**SUNDRY NOTICES AND REPORTS ON WELLS**  
Do not use this form for proposals to drill or to re-enter an abandoned well. Use form 3160-3 (APD) for such proposals.

| 3a. Address<br>600 N. DAIRY ASHFORD ROAD<br>HOUSTON, TX 77079 1175  | 3b. Phone No. (include area code)<br>Ph: 281-206-5282 | 8. Well Name and No.<br>WILDER FEDERAL AA 29 6H                        |

| TYPE OF SUBMISSION                                   | TYPE OF ACTION                                |   |  |   |
|--|---|---|--|---|
|  | <input type="checkbox"/> Change Plans         | <input type="checkbox"/> Plug and Abandon | <input type="checkbox"/> Temporarily Abandon       | Change to Original APD                    |

WILDER FEDERAL AA 29 6H  
BACKFILL AROUND PIPE

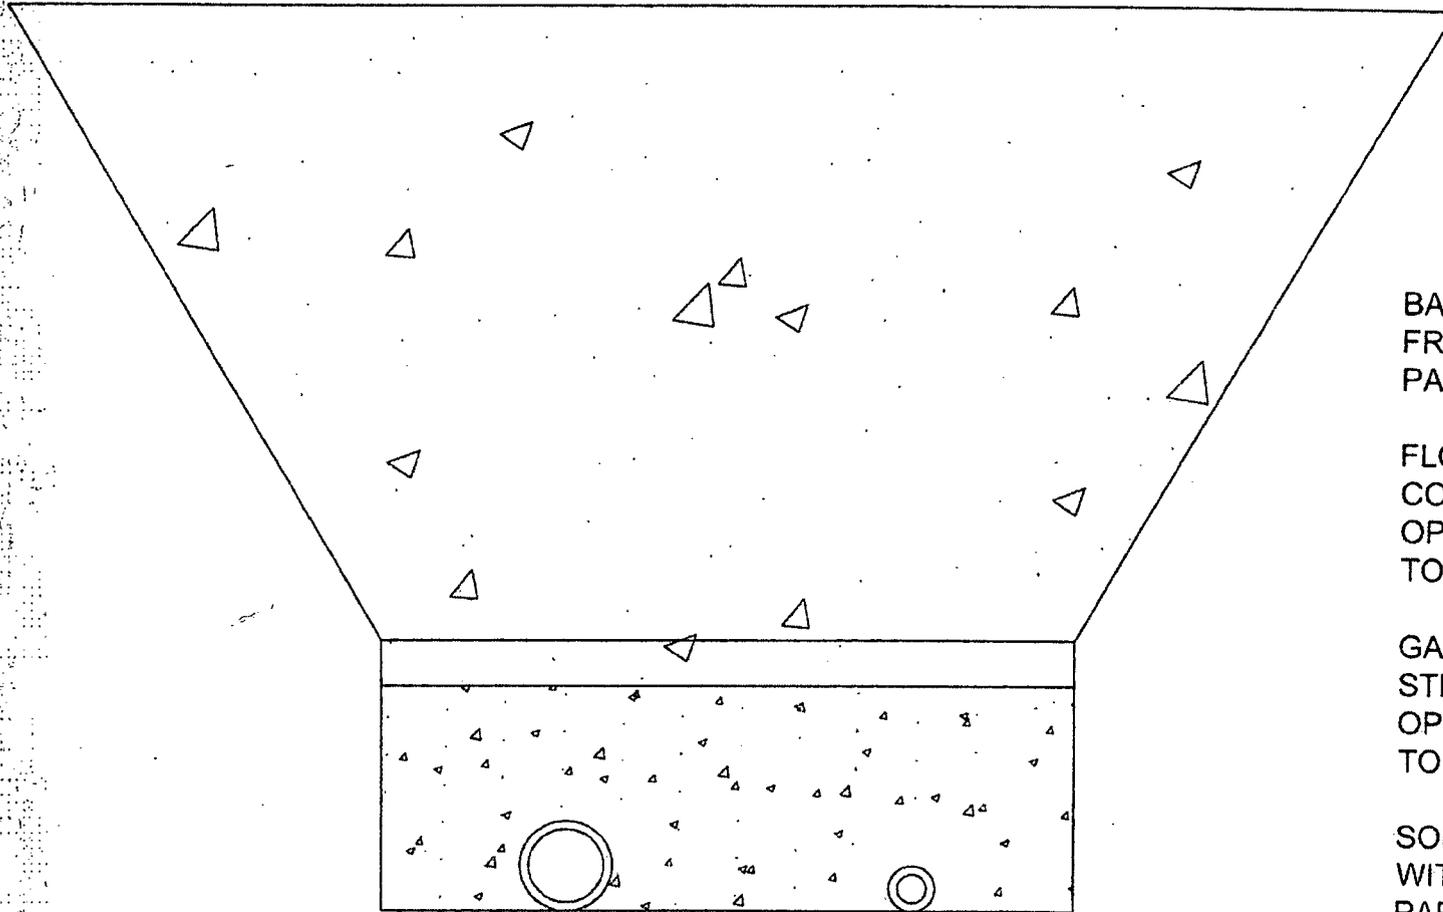
ConocoPhillips Company respectfully requests to amend the method of installation as it pertains to the products line from surface to buried. The route for the pipeline has not changed. The line will be 4' Steel, operated at up to 1480# psi from the well to the Wilder 29 Central Tank Battery. All activity will be kept in the utility corridor already authorized under the APD.

In addition, per conversation with Cody Layton on 02/18/2014, ConocoPhillips Company respectfully requests to amend the Conditions of Approval for the authorized ROW width of 15' in the APD. A larger ROW width is needed for ConocoPhillips Company to comply with our internal safety practices governing separation between buried lines and roadways. We request the ROW width be amended to 30' permanent with 20' construction workspace.

BACKFILL DIRT TO BE AS  
FREE OF ROCKS AND LARGE  
PARTICLES AS POSSIBLE

FLOW LINE WILL BE 4"  
COATED STEEL PIPE w/ AN  
OPERATING PRESSURE UP  
TO 1480# PSI.

GAS SUPPLY LINE WILL BE 2"  
STEEL PIPE w/ AN  
OPERATING PRESSURE UP  
TO 1100# PSI. (Previously Approved Under  
APD)

SOFT FILL DIRT OR SAND  
WITH NO ROCKS OR SOLID  
PARTICLES GREATER THAN  
1" IN CIRCUMFERENCE
